TO: HONORABLE CHAIRMAN AND PLANNING COMMISSION  
FROM: RON WHISENAND, COMMUNITY DEVELOPMENT DIRECTOR  
SUBJECT: TENTATIVE PARCEL MAP PR 04-0189, AT 319 4<sup>th</sup> STREET  
(APPLICANT: MARQUEZ)  
DATE: DECEMBER 12, 2006

## **MEMORANDUM**

**TO:** Darren Nash  
**FROM:** John Falkenstien  
**SUBJECT:** PR 04-0189  
**DATE:** December 12, 2006

A RESOLUTION OF THE PLANNING COMMISSION  
OF THE CITY OF EL PASO DE ROBLES  
TO GRANT TENTATIVE MAP APPROVAL FOR  
PARCEL MAP PR 04-0189  
(MARQUEZ)  
APN: 009-241-004

**EXISTING RESIDENCE WITH NEW CARPORT**  
*EXHIBIT B-2*

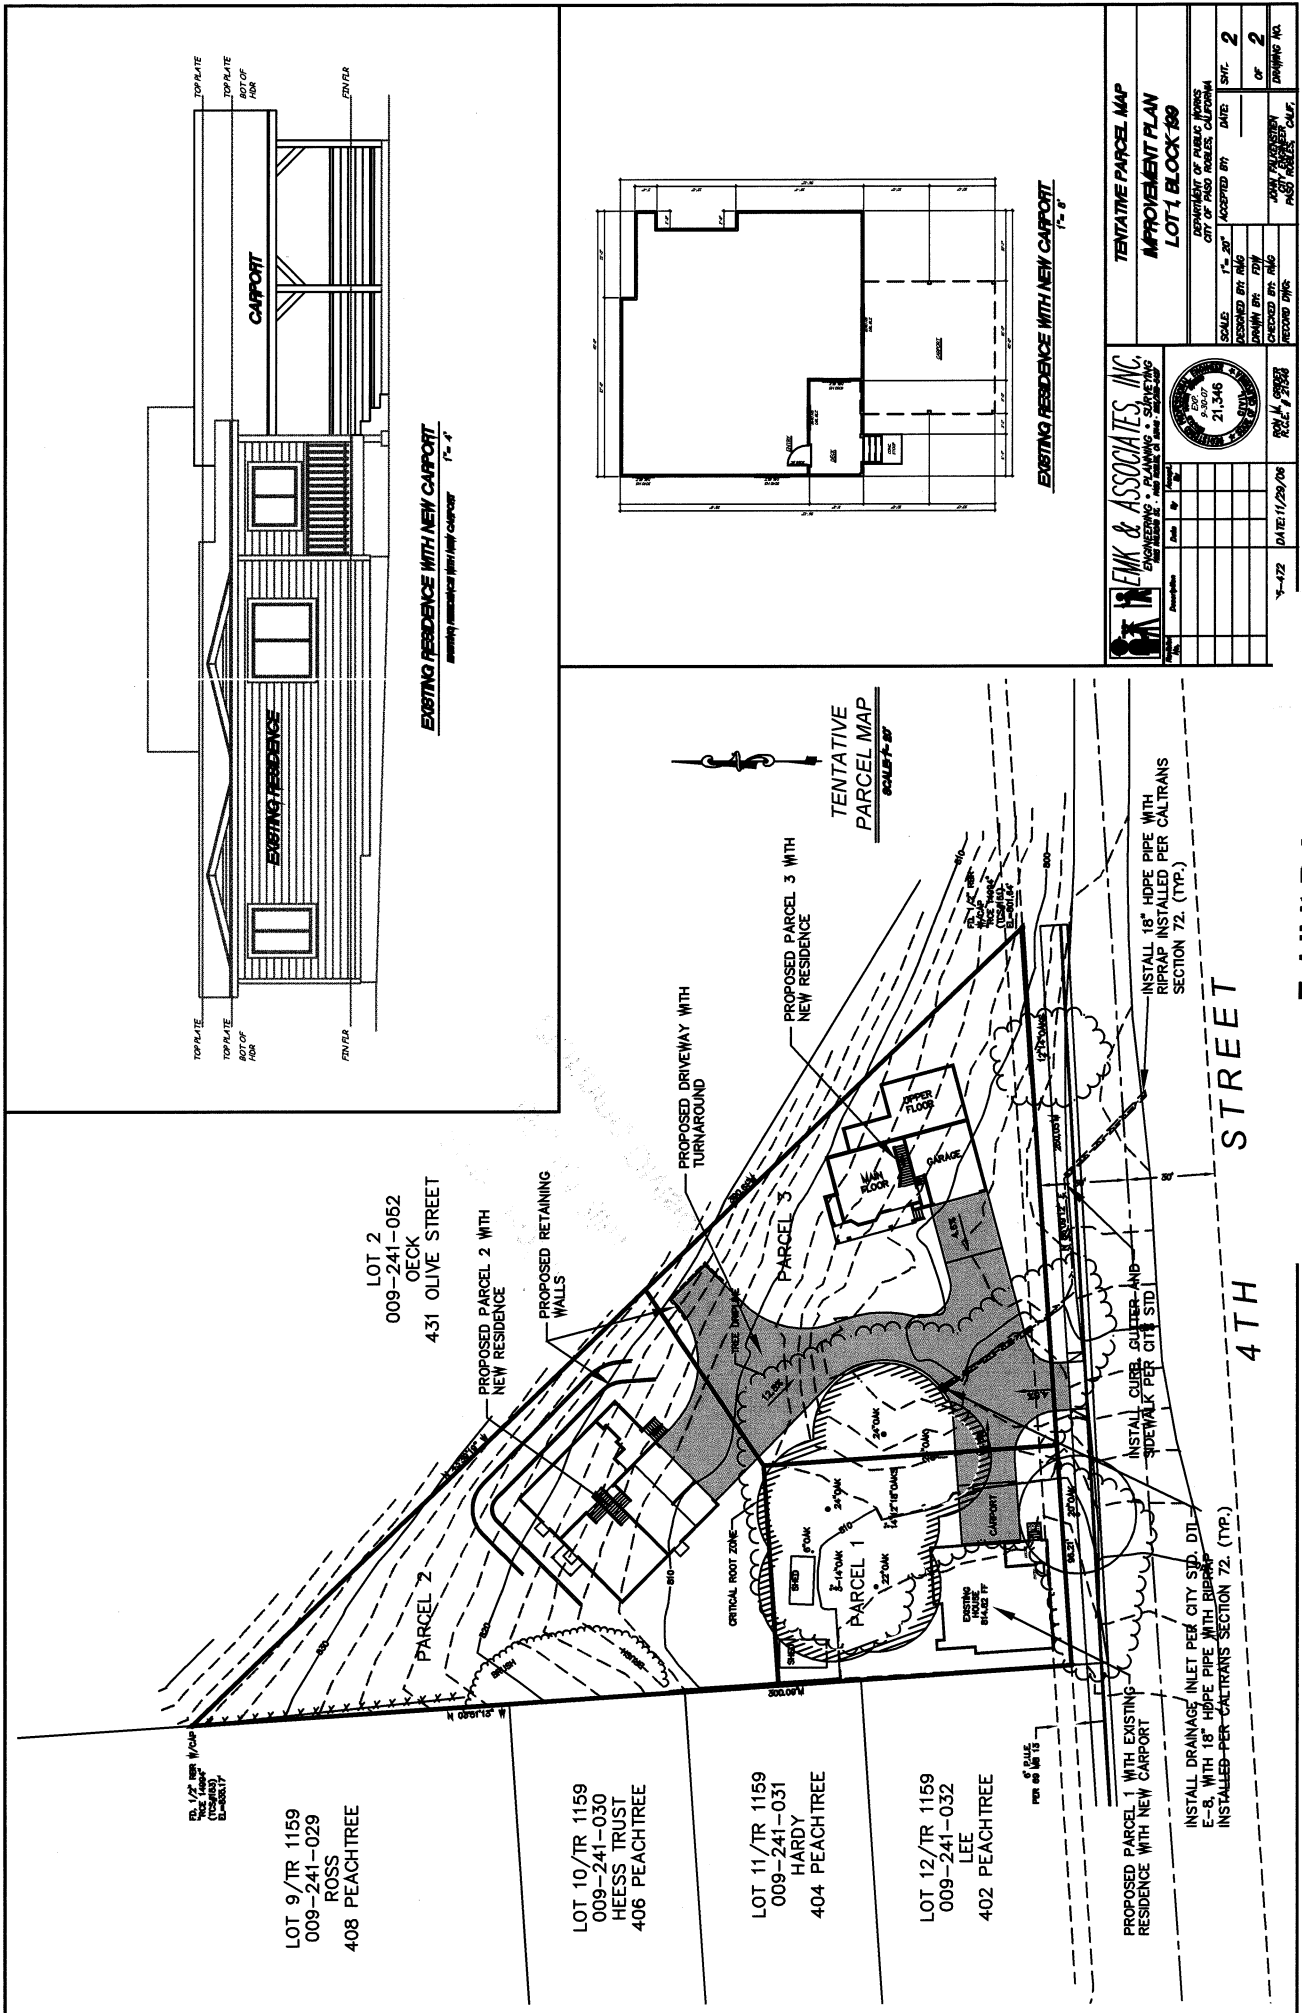
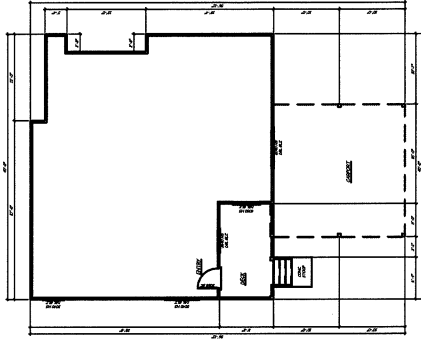
6. Prior to the recordation of the Parcel Map, the carport as shown on Exhibits B-2 & E-2 shall be installed, along with the paved driveway. Note: a temporary paved driveway may be necessary until the final shared driveway that will access parcel 2 and 3 is constructed.
7. Prior to the issuance of a building and/or grading permit for the carport or either of the homes on Lots 2 and 3, a letter from the project arborist shall be submitted indicating that the property tree protection measures have been installed.

**Arborist Report**  
**Tree location Map**

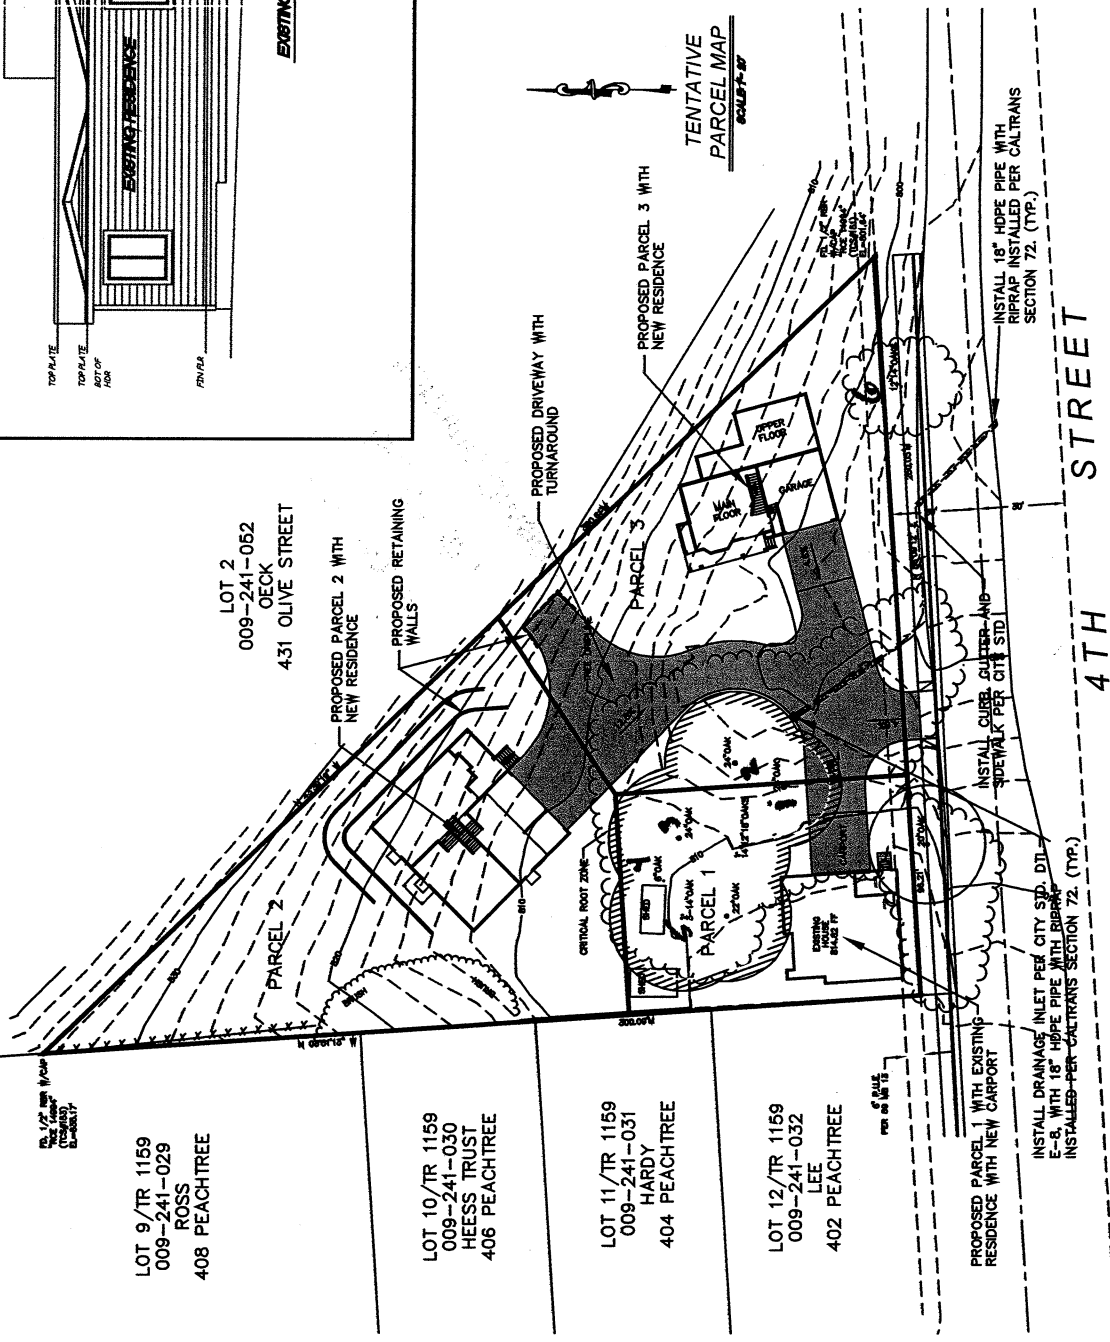
**Specific Mitigations to this Project:** As stated above, shift the building envelope (proposed parcel 2) ten feet north and follow the building plan descriptions. All applicable mitigation measures described below shall be followed.
